REMARKS/ARGUMENTS

Claims 1-9 are pending in the application with claims 1-2 rejected.
Reexamination and reconsideration are hereby requested.

FIG. 2
(PRIOR ART)

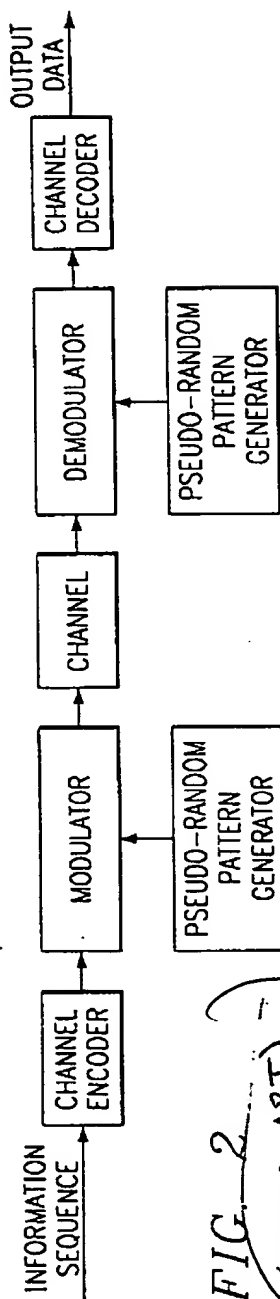
Proposed amendments to add "Prior Art" to Figs.2-5b are indicated in the Appendix in red.
